ADDENDUM NO. 2

FEBRUARY 28, 2024

Staunton City Public Schools, VA
Shelburne Middle School Additions and Renovations
CRA Project No. 3636

PARTIAL FIRST FLOOR PLAN -
ADDITION (ALTERNATE #1)
PLOT SCALE:
As indicated
FILENAME:
DATE:
01/24/2023

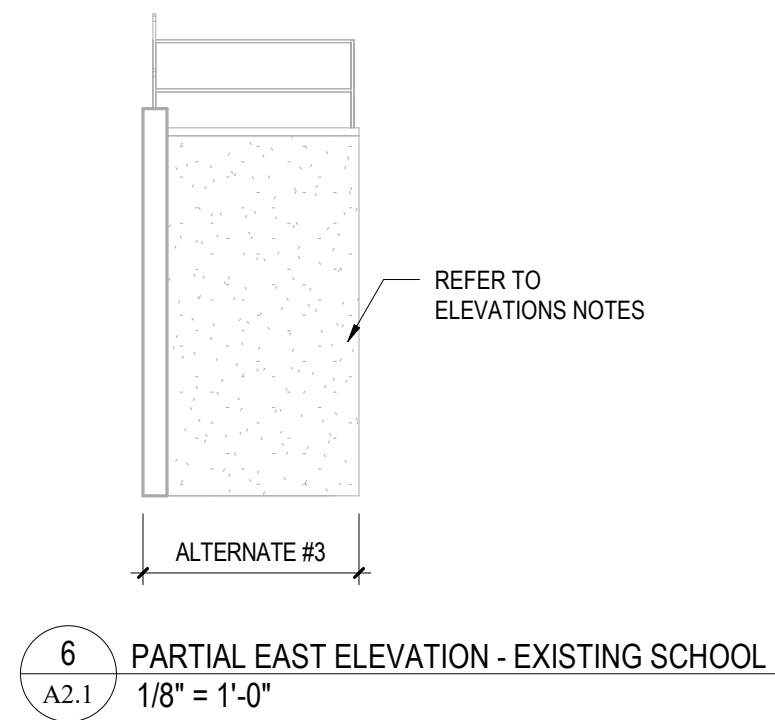
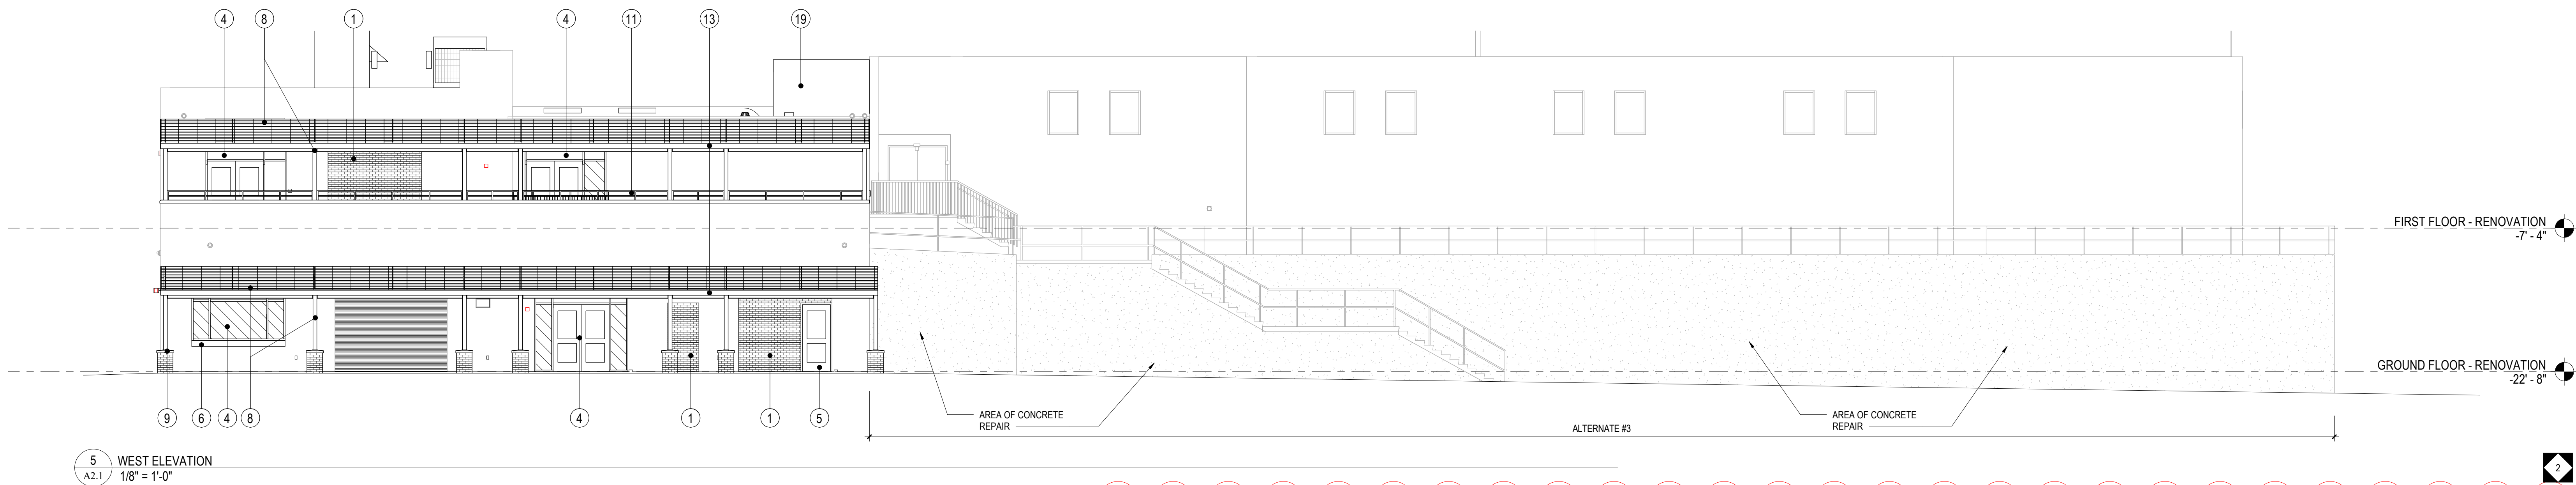
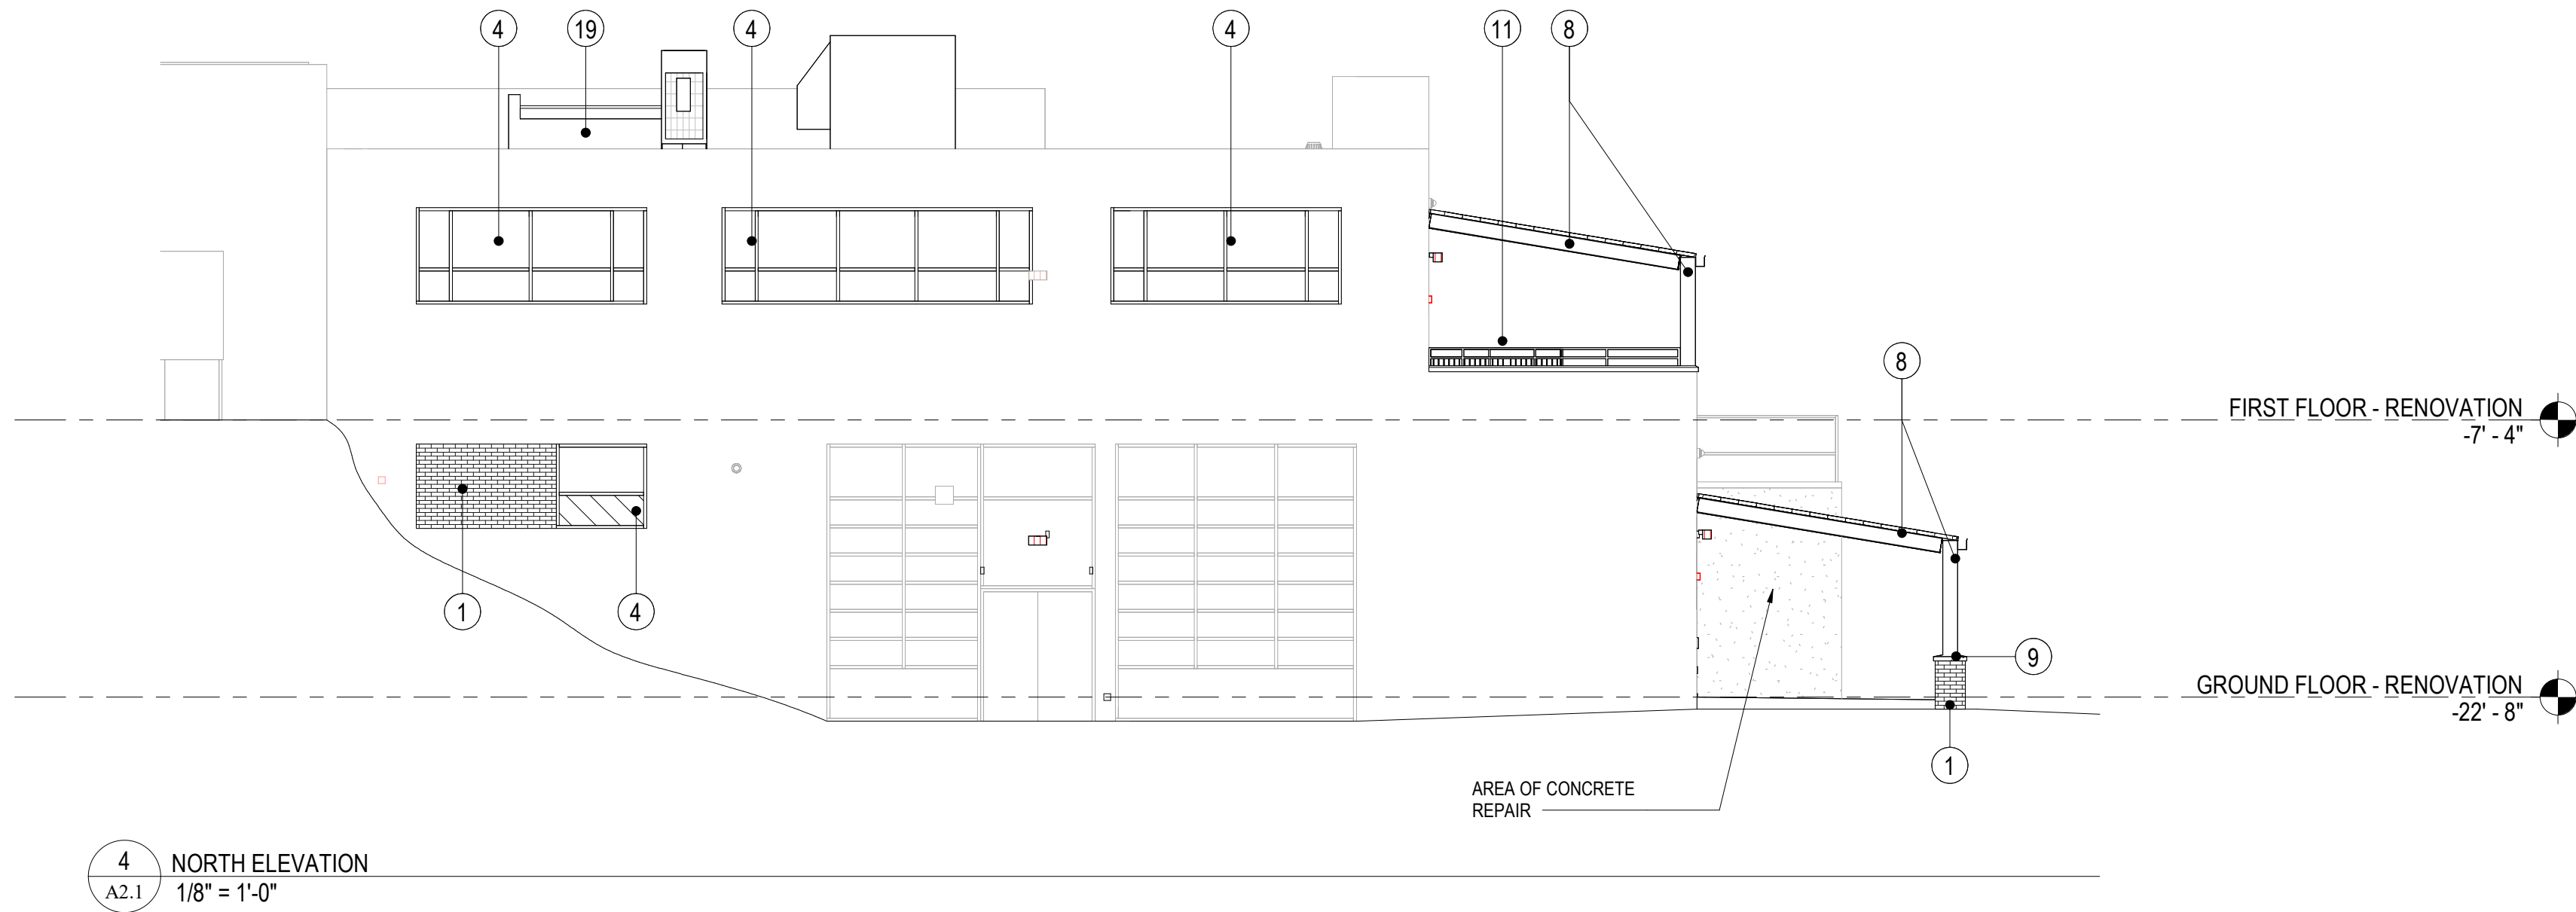
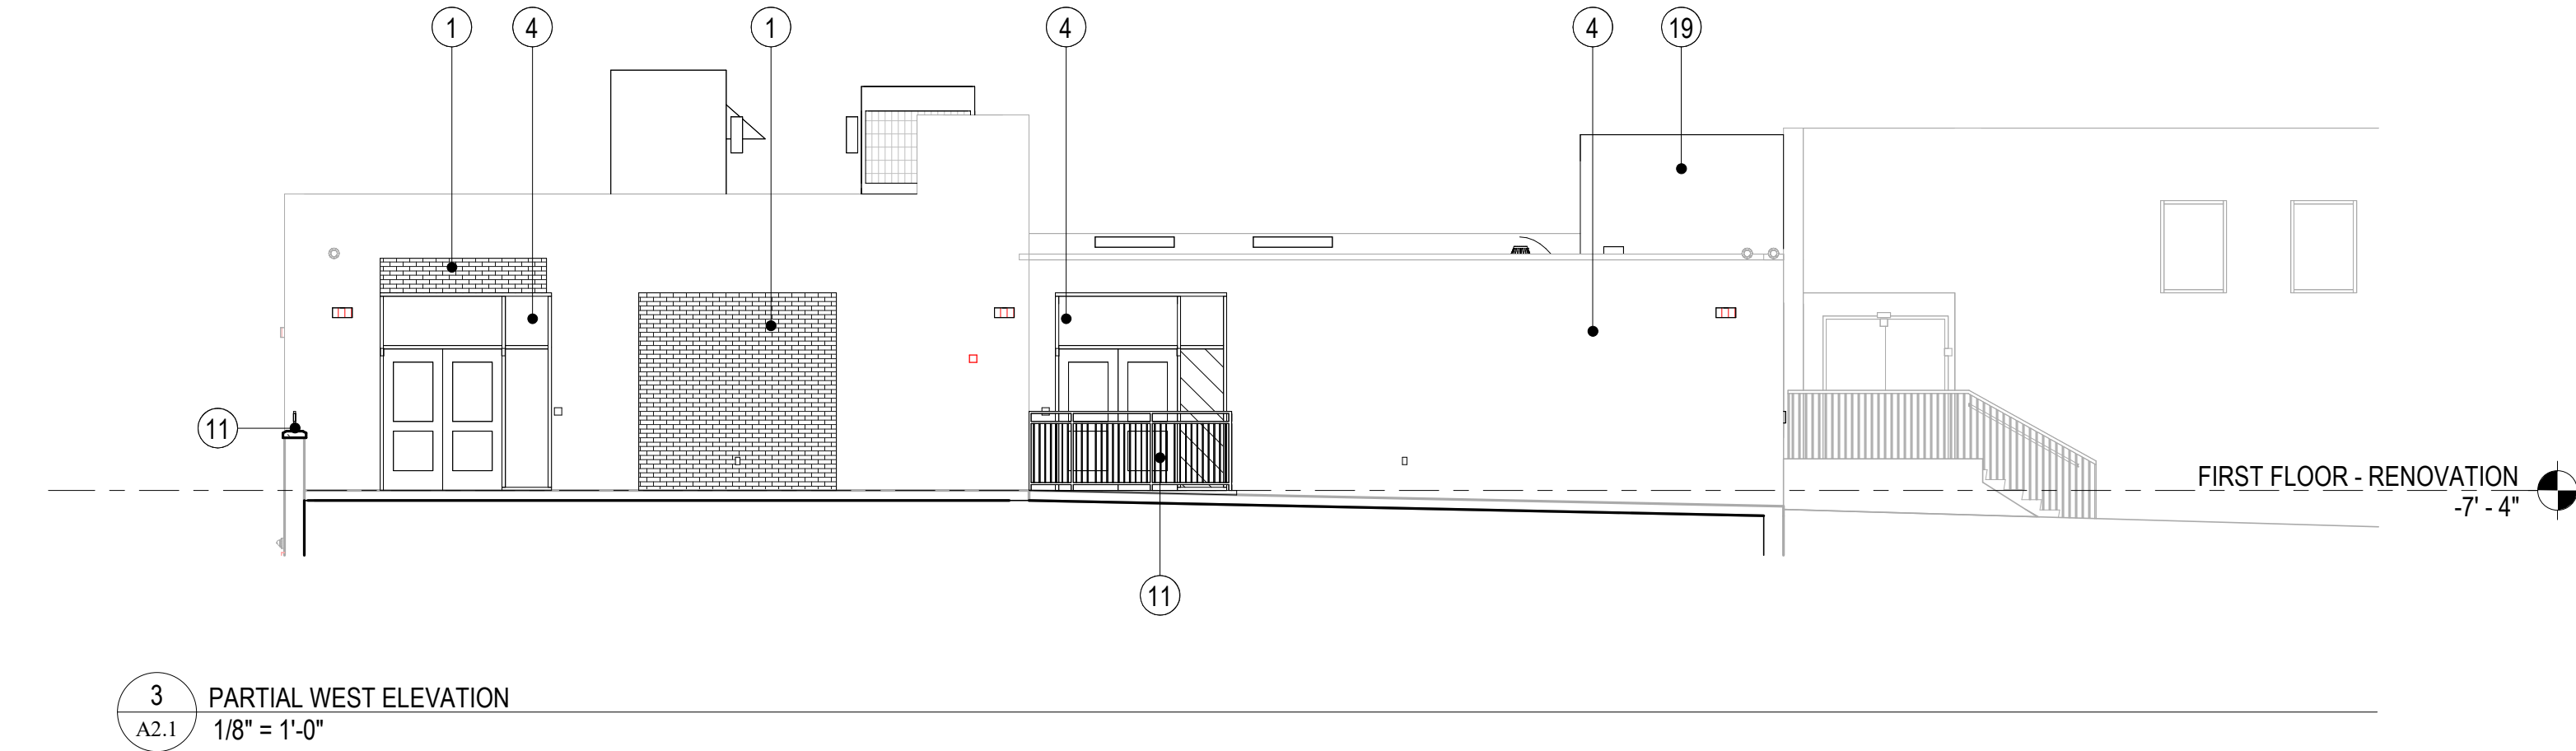
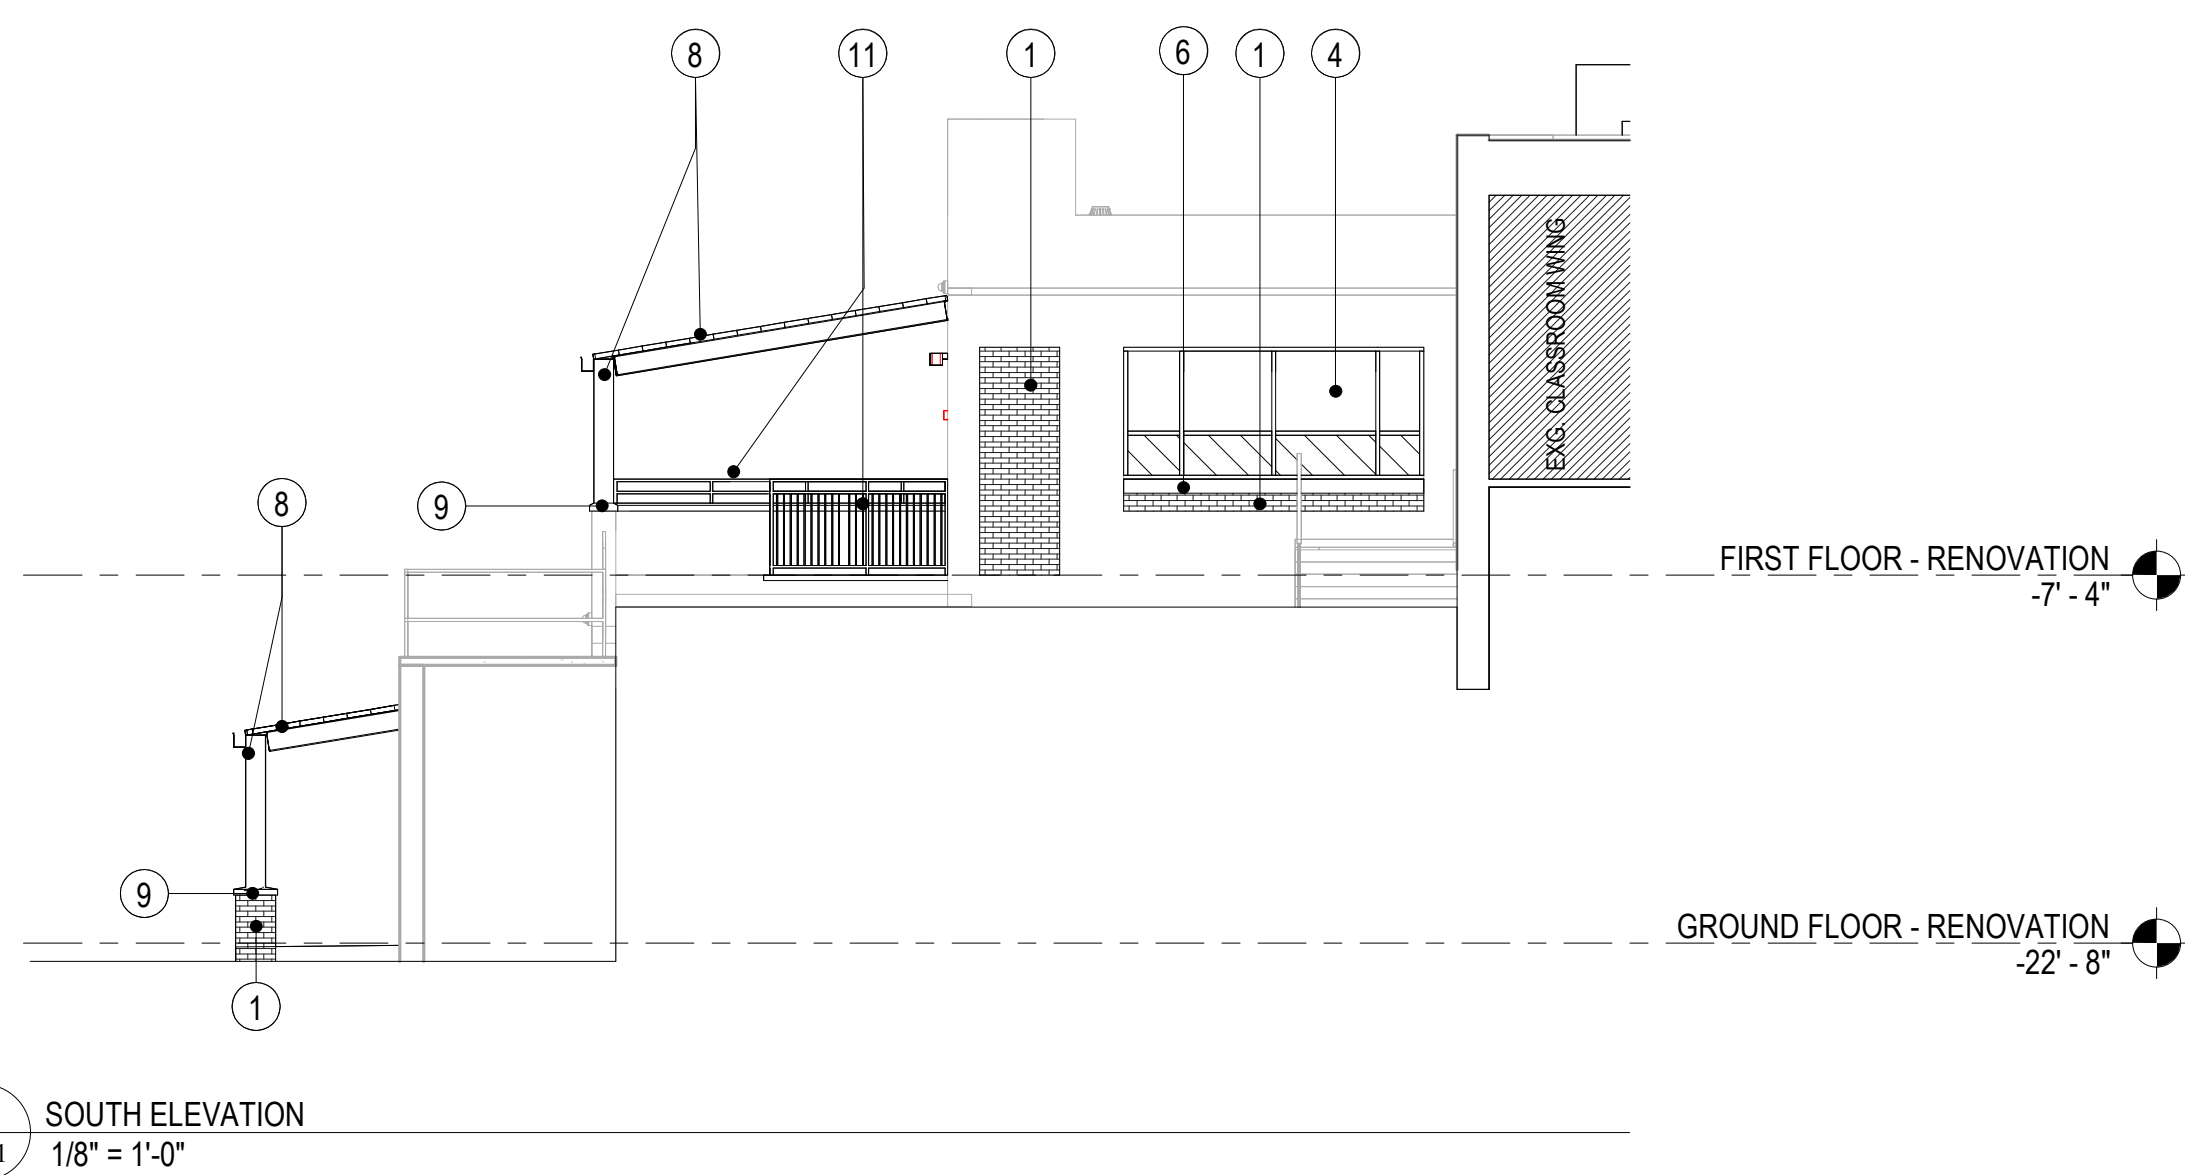
1. **DELETE** this sheet in its entirety and **REPLACE** with the attached sheet.
 - a. **REVISED** Telescopic Platform and seating layout.
